Design Review & Historic Preservation Board Meeting Agenda

Design review application - Downtown Design Guidelines (DDGs) - 2nd Street Apartments - REVISION

RE: PUYALLUP SECOND STREET APARTMENTS

Staff Review Table - PLDDG20240024

2nd Street Apartments - Puyallup	
Exterior Elevations - w/ foliage	
04-08-24	Page 3 of 6

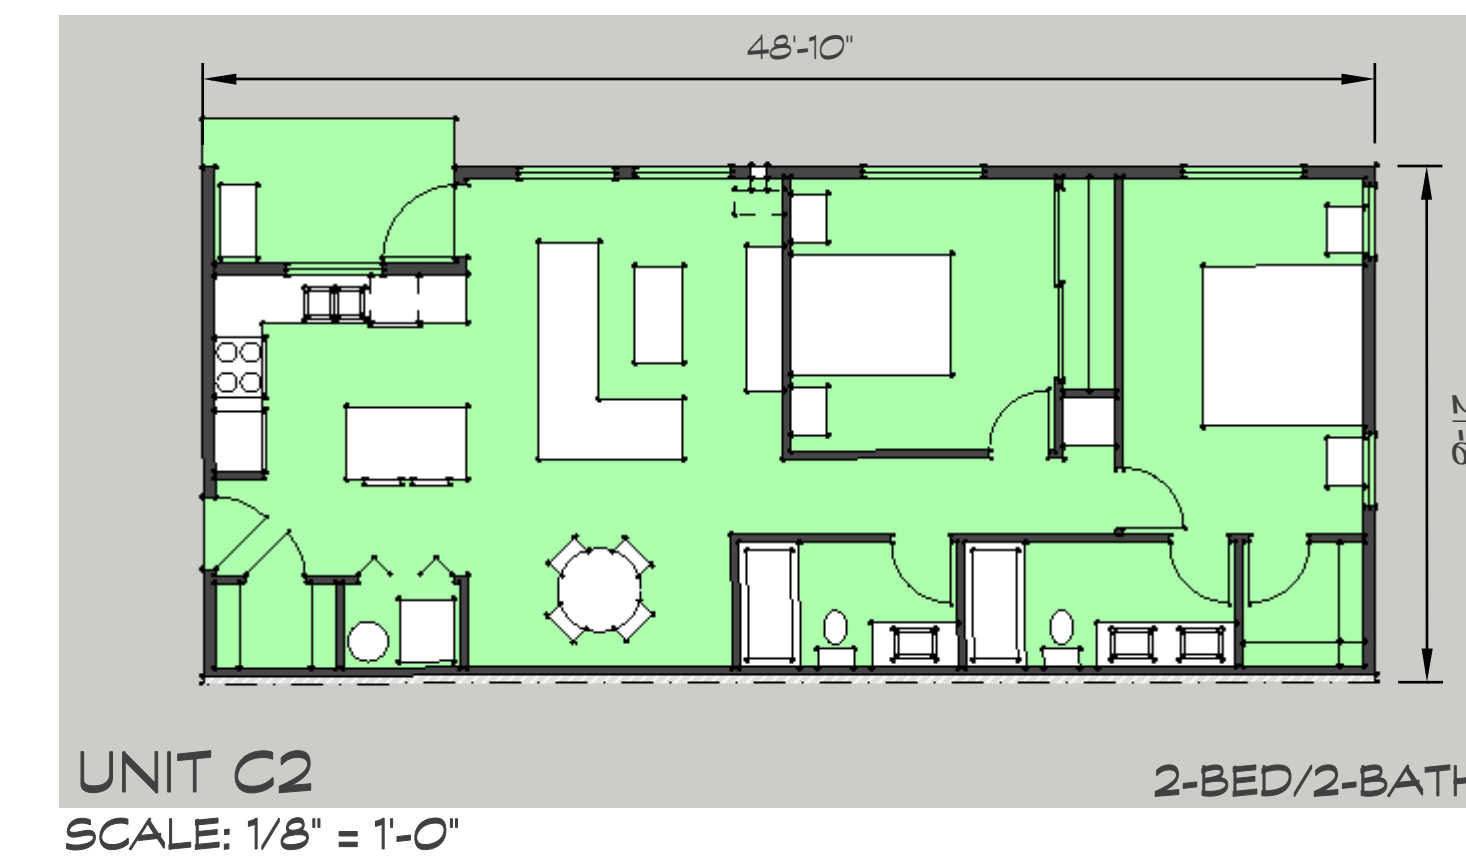
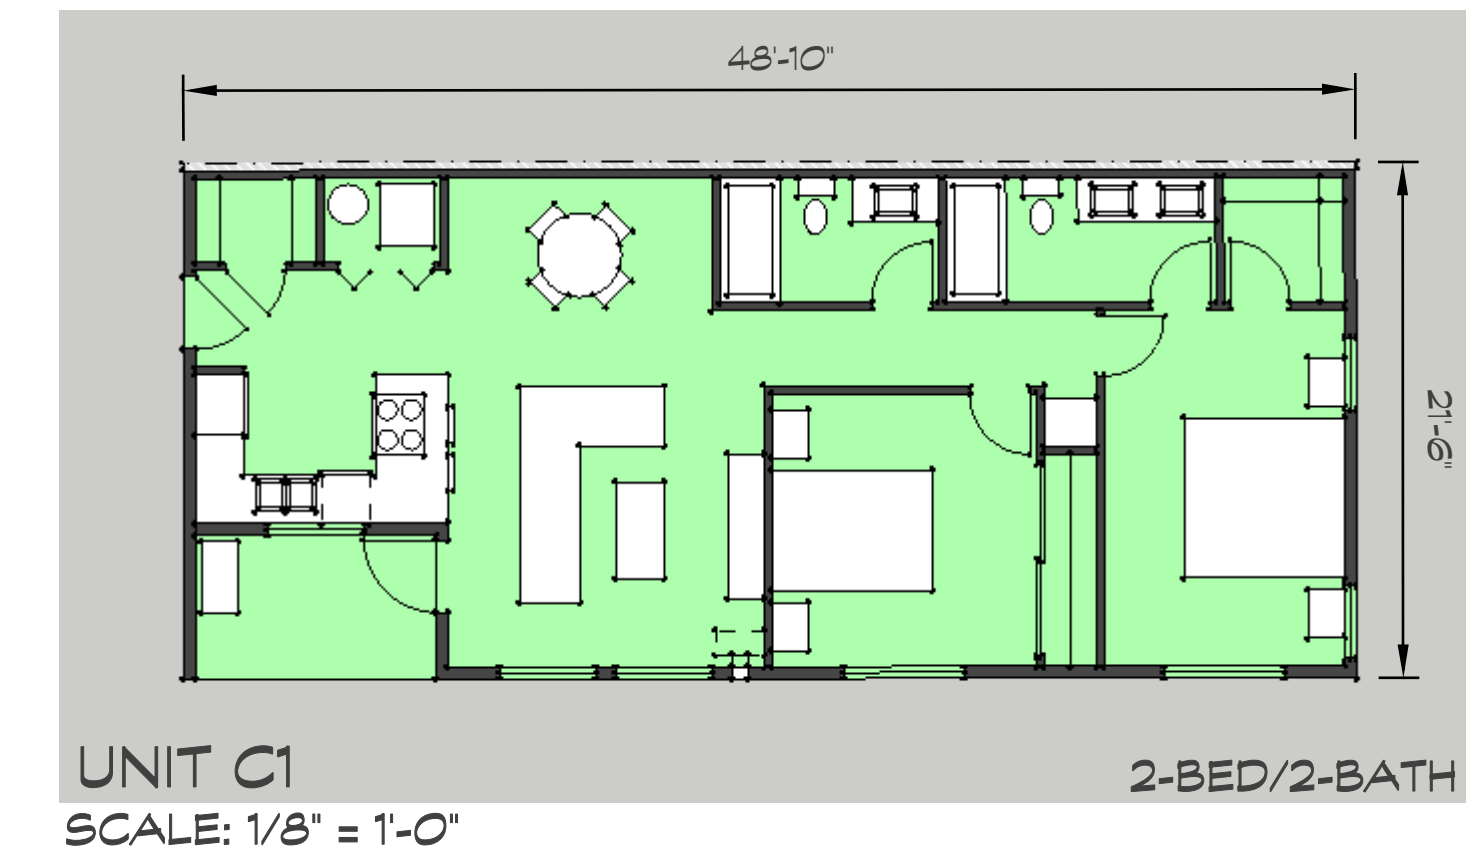
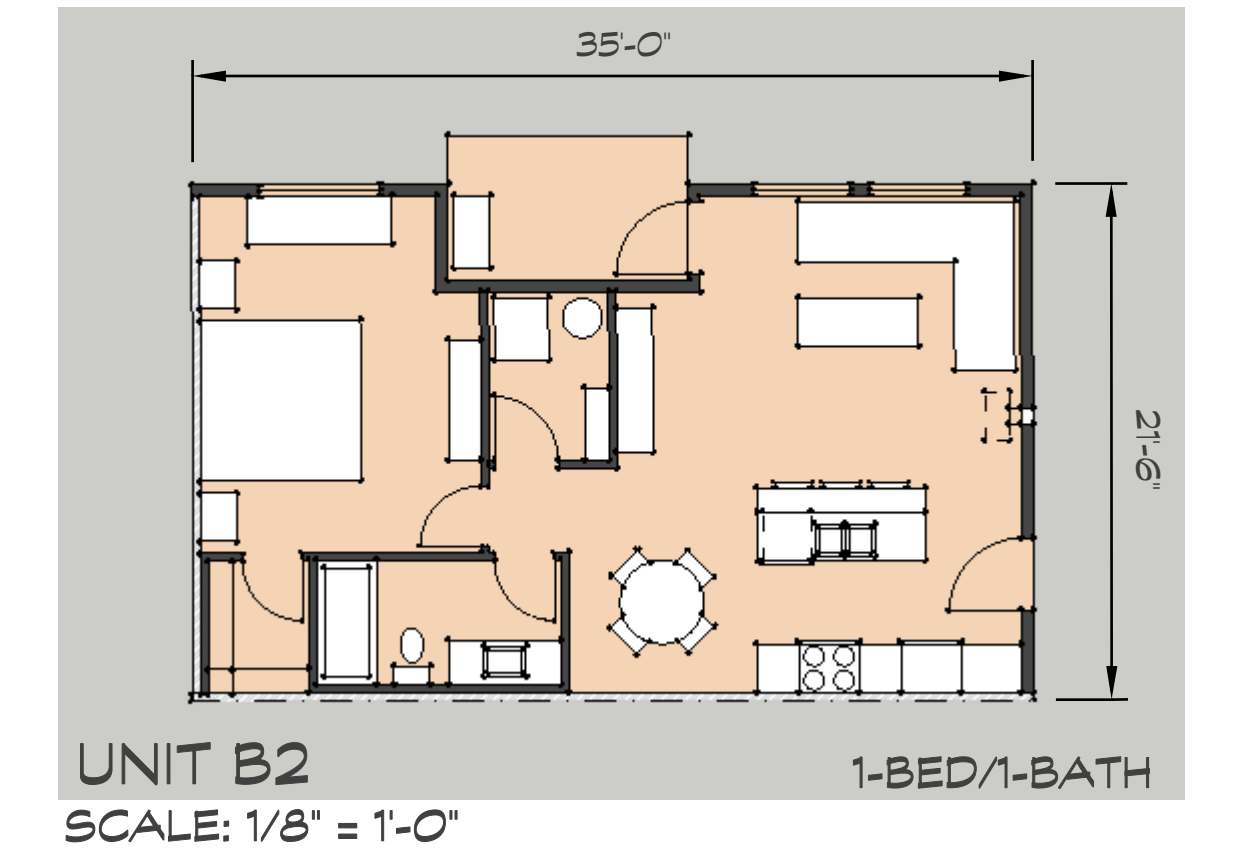
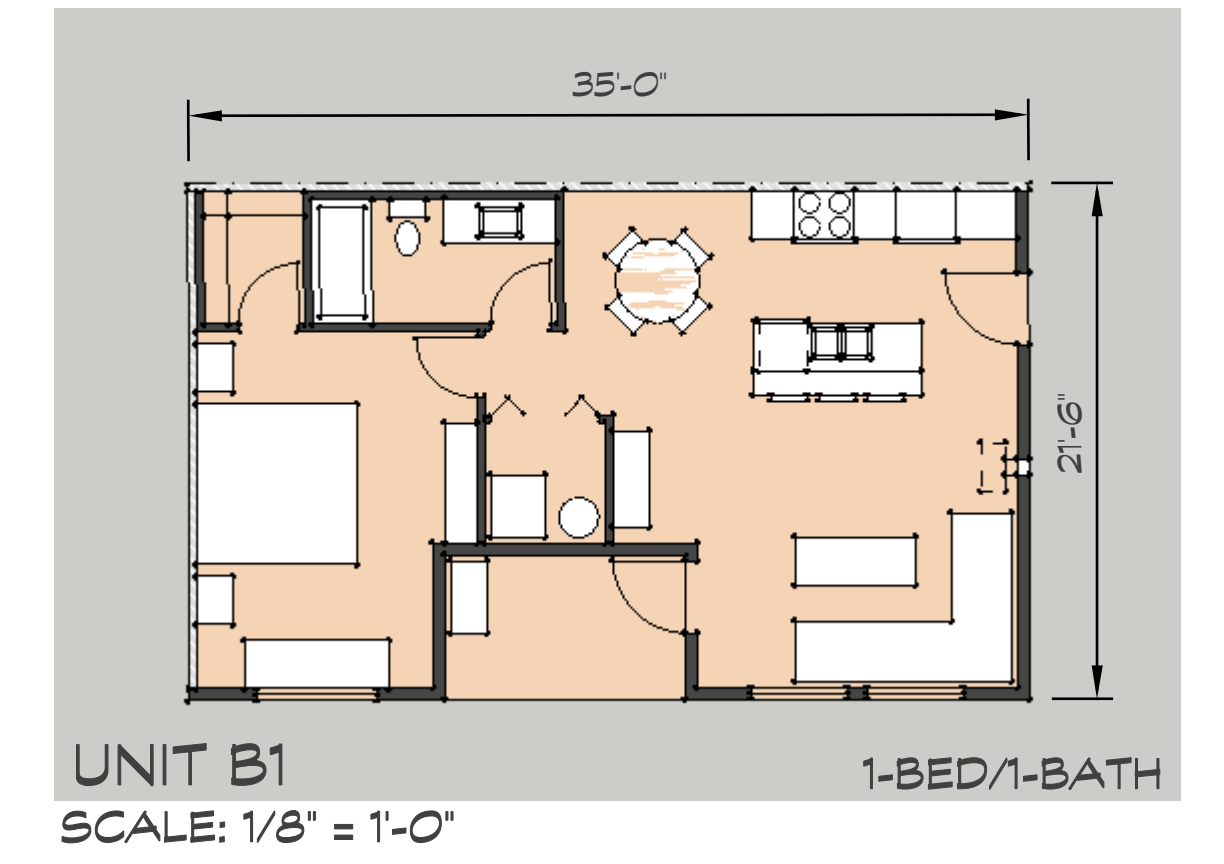
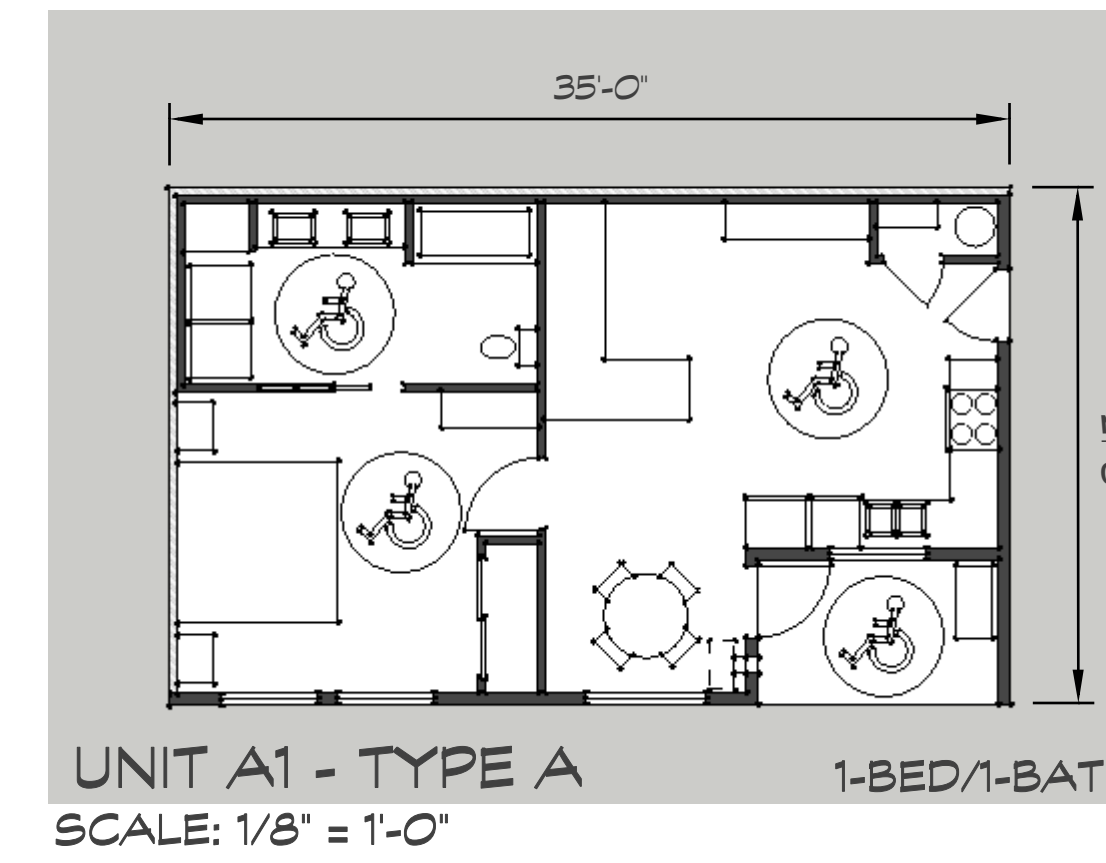
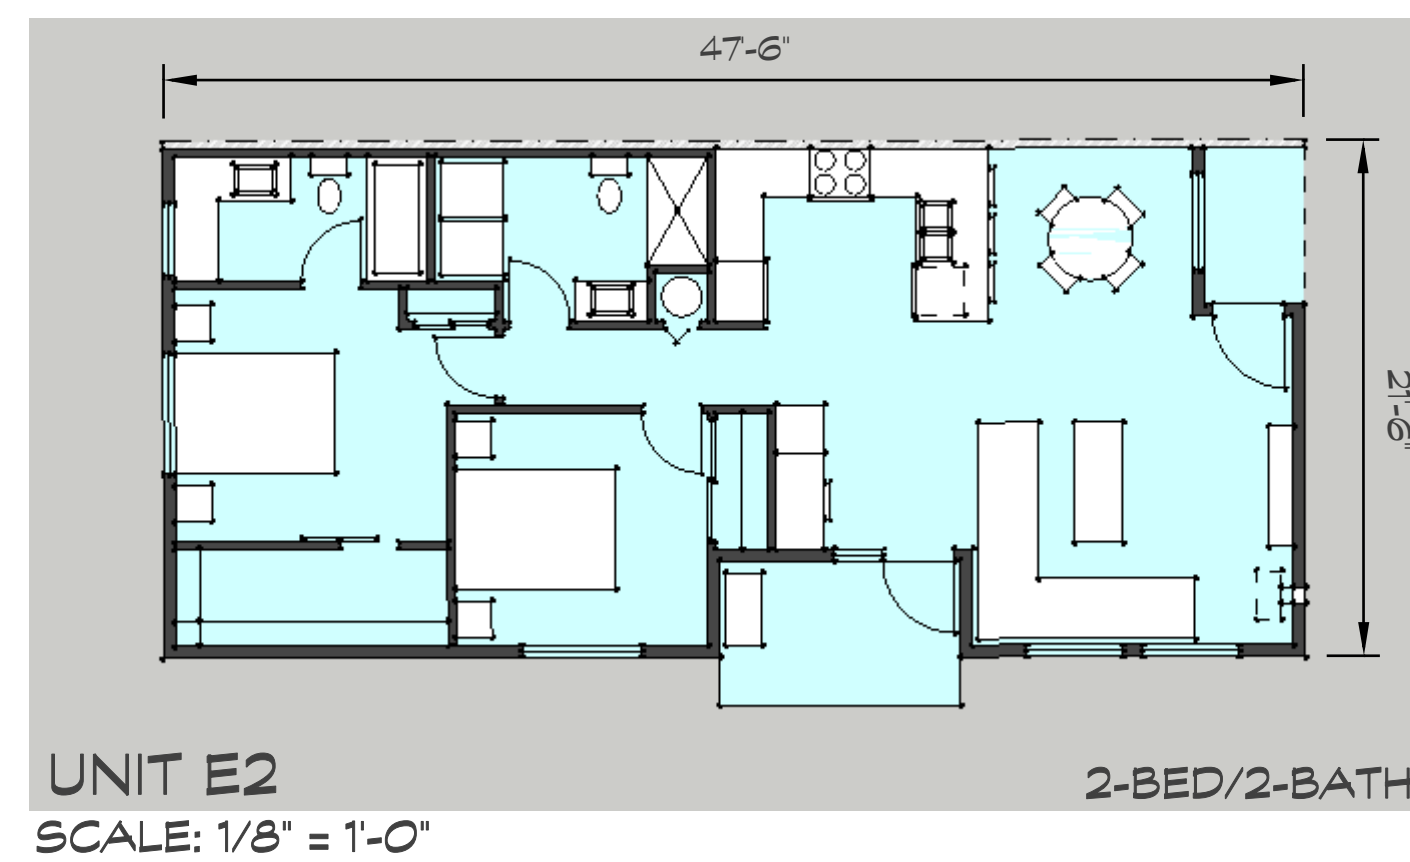
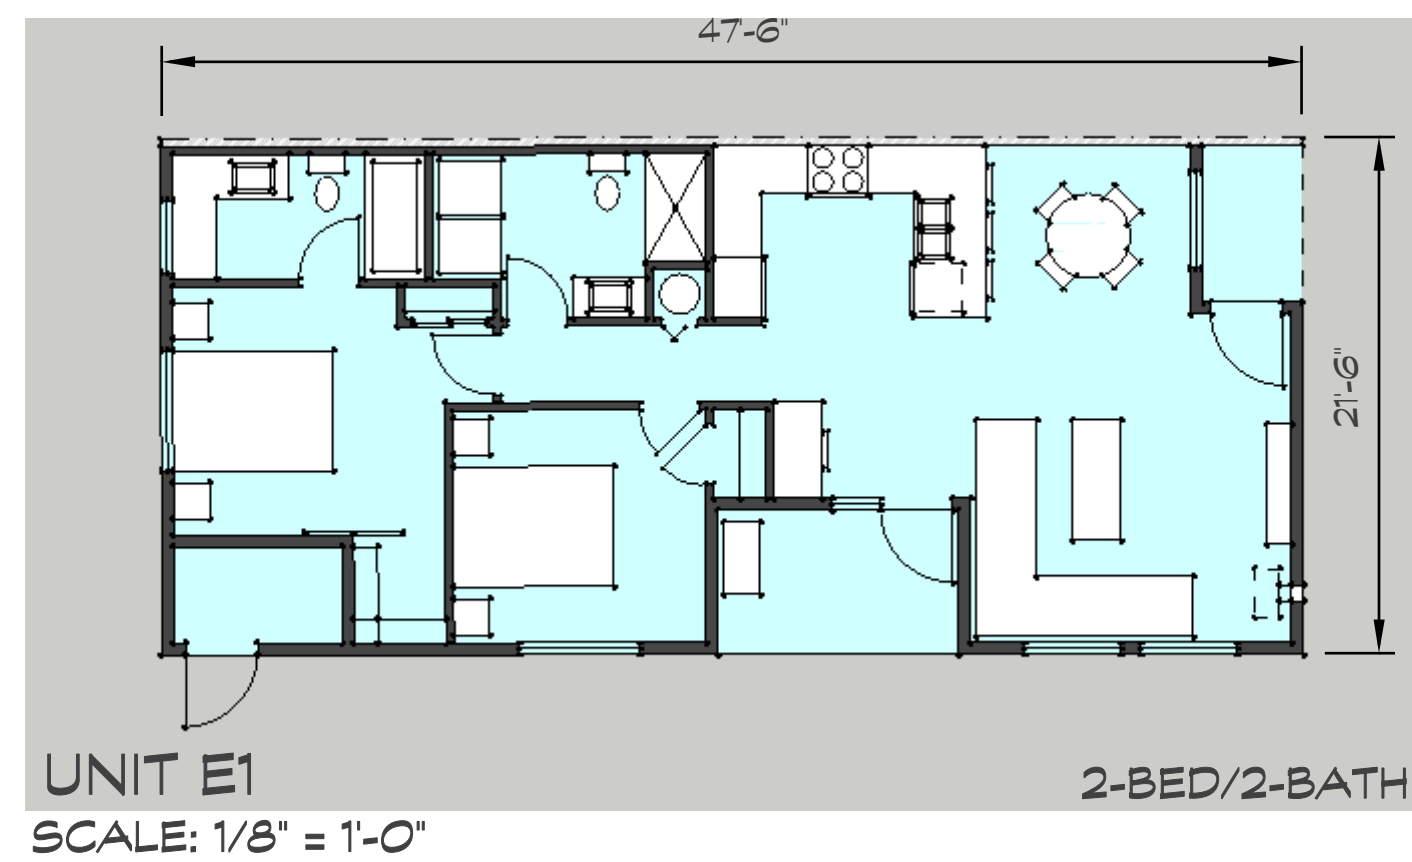
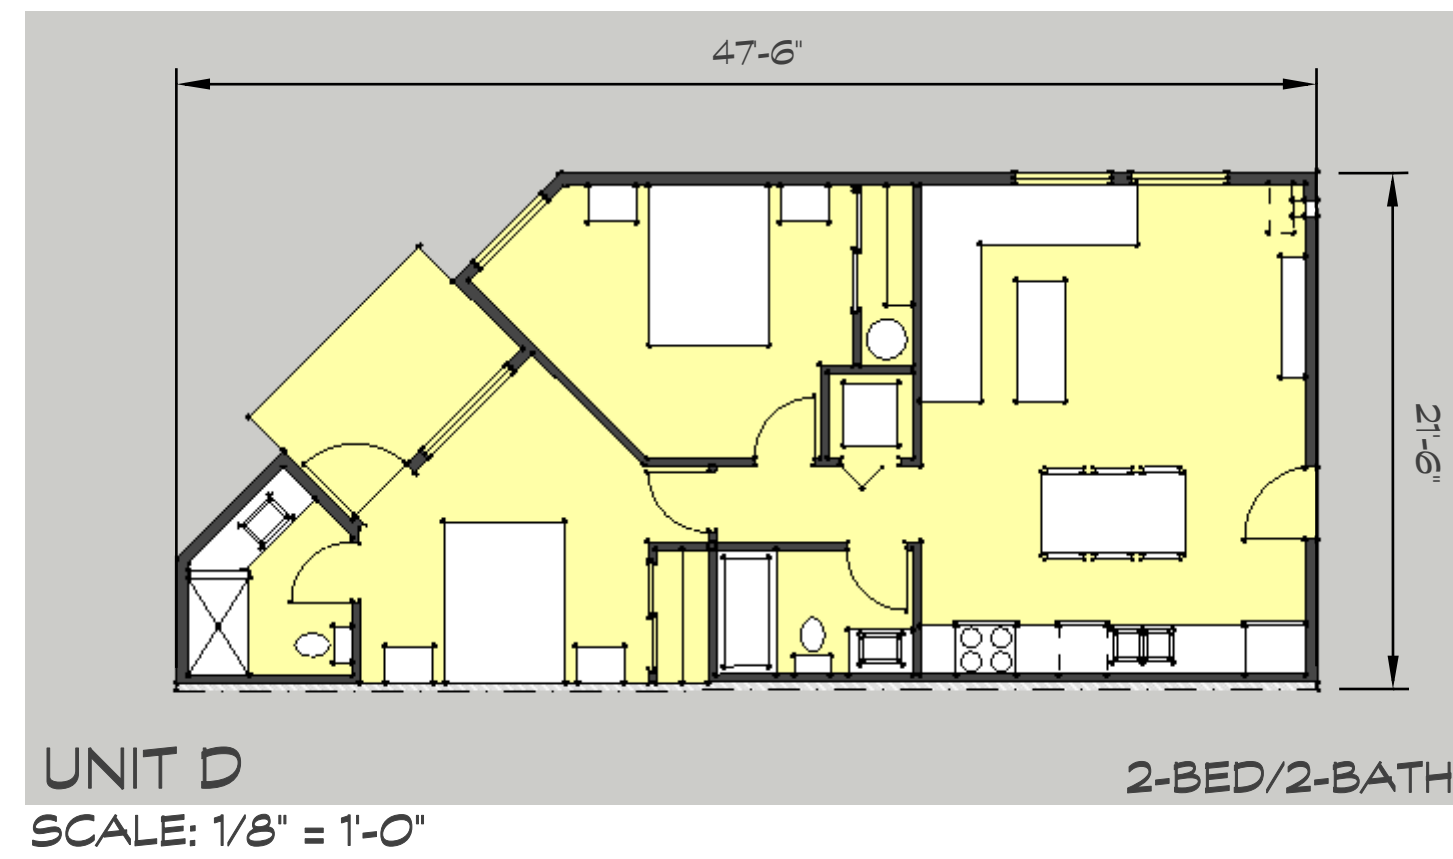
<p>3</p>	<p>Provide glazed doorways where appropriate.</p>	<p>Yes</p>	
	<p>5</p>	<p>A minimum of 30% transparency within the pedestrian view plane should be achieved for ground floor residential buildings.</p>	<p>Needs Board Review</p>	<p>South façade only provided with 11% transparency</p>
	<p>5.B.4</p>	<p>Building Entries. Enhance public safety while reducing opportunities for vandalism. Building entries include commercial building entries, residential building entries, garage entries, fire exits, and service/utility access. This strategy is required at all street-facing façades.</p>		
	<p>1</p>	<p>Align primary building entries with pedestrian points of access. Consider transit stops, cross walks, public open spaces, and/or building design (massing and façade) strategies.</p>	<p>Yes</p>	
	<p>2</p>	<p>Avoid locating garage entries and building services (utility and/or trash rooms) along the primary pedestrian façade.</p>	<p>Yes</p>

- 4.B.1 – section 5. See staff review table, page 4 of 9.
- 4.B.2 – Façade composition. See staff review table, page 4 of 9. Staff needs Board feedback on the applicable criteria relative to project design.
- 4.B.4 – Façade modulation. See staff review table, page 4 of 9. Staff needs Board feedback on the applicable criteria relative to project design.
- 4.B.6 – section 1-5. See staff review table, page 5/6 of 9. Staff needs Board feedback on the applicable criteria relative to project design. See architect’s further explanation of

siding proposal in project narrative (last page). Staff needs Board guidance on appropriate control joints for the stucco siding material and for the Board to weigh in on the siding coverage percentages shown on the plan sets.
